Subway adjacent to Paisley
Road.

FOUNDATION INVESTIGATION REPORT
For
The Proposed C.N.R. Subway #1 Over
Hanlon Expressway, City of Guelph
District #3, Stratford.
W.O. 72-11041 -- W.P. 109-68-10

SUBJECT: W.P. 109-68-10, Bridge Site 35-408
C.N.R. Subway #1
Hanlon Expressway Sta. 91 + 07.79
District 3, Stratford

W.P. 109-68-10 W.O. 72-11041
C.N.R. Subway #1, Hanlon Expressway
City of Guelph, District #3 (Stratford)

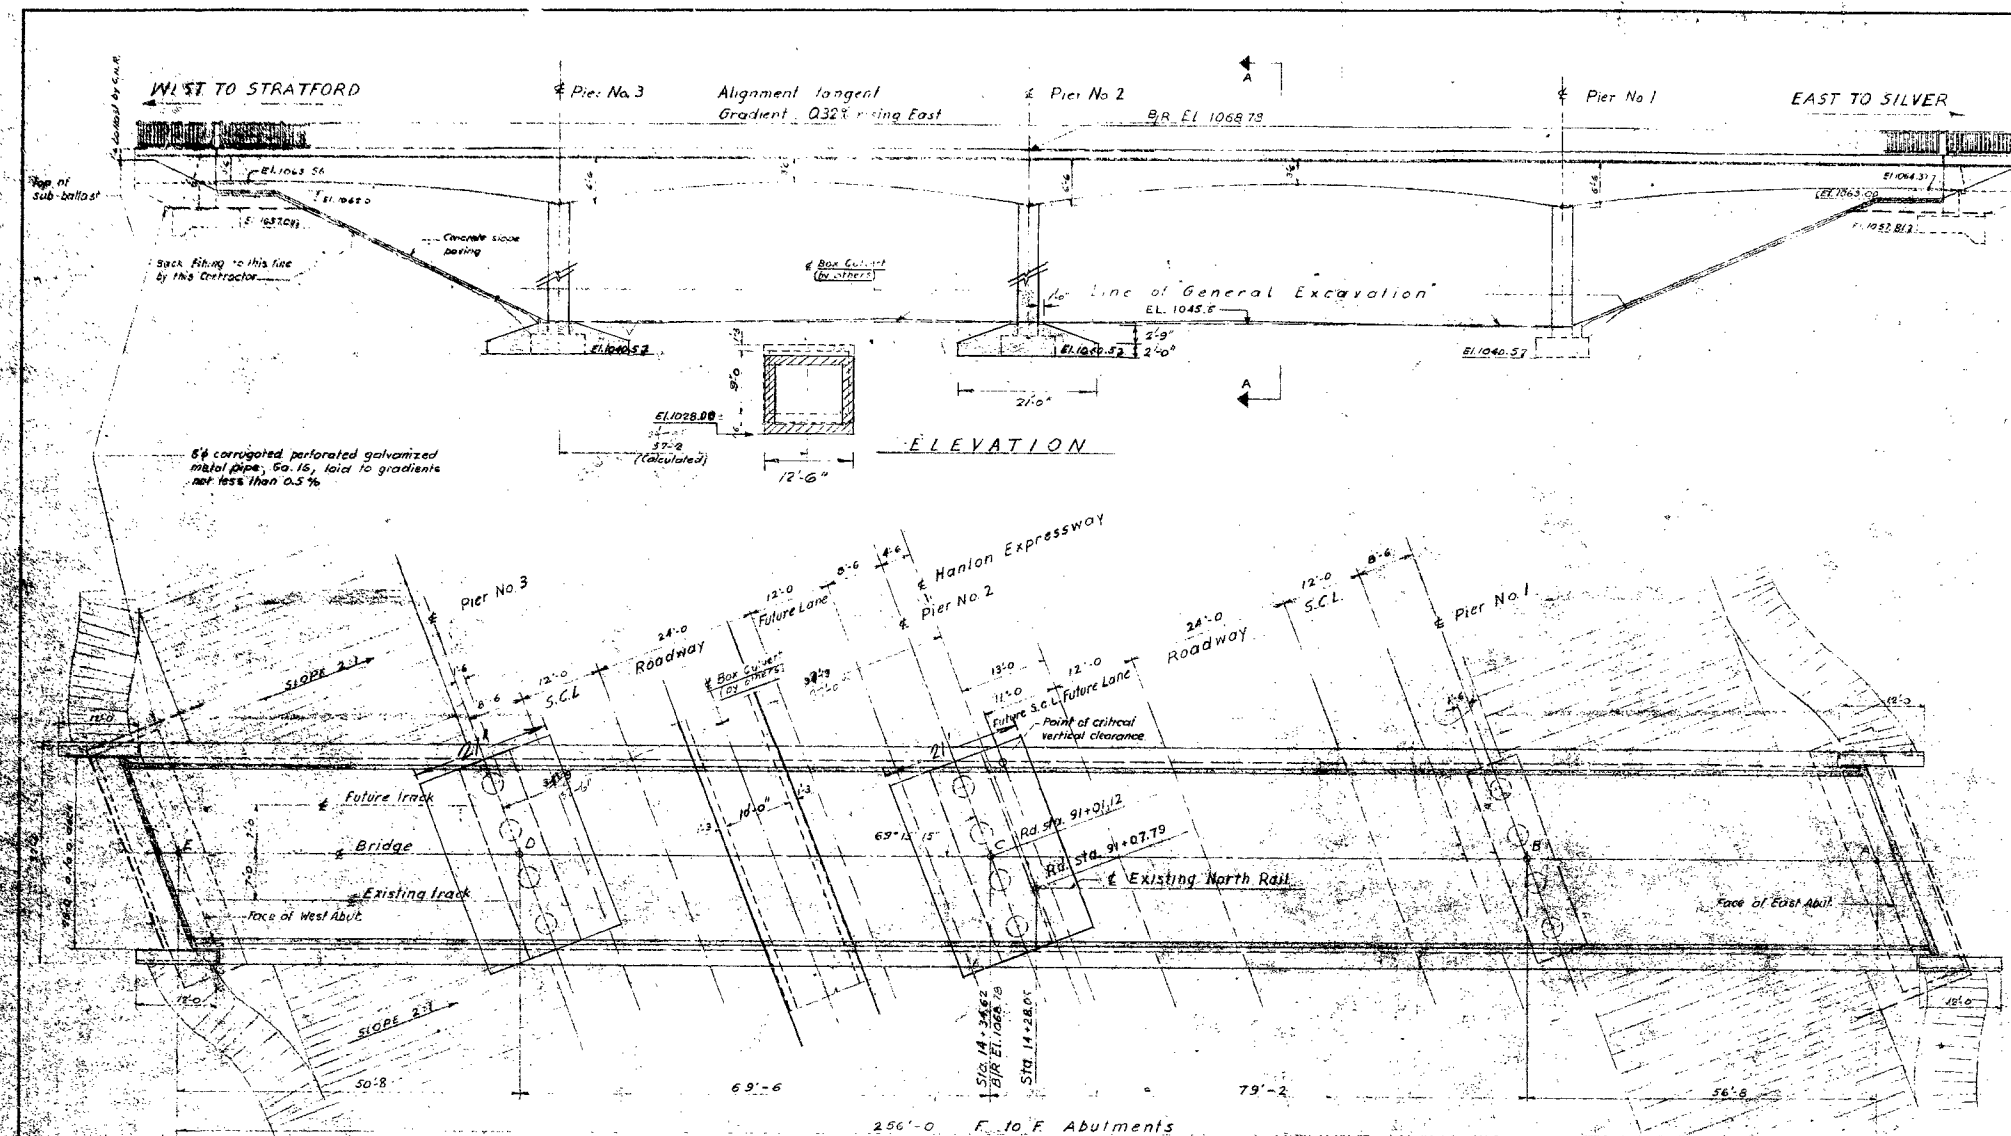
No comments

We have reviewed the general layout drawing for the above project and find it to be in accordance with the recommendations contained in our foundation investigation report.

We have no comments to make.
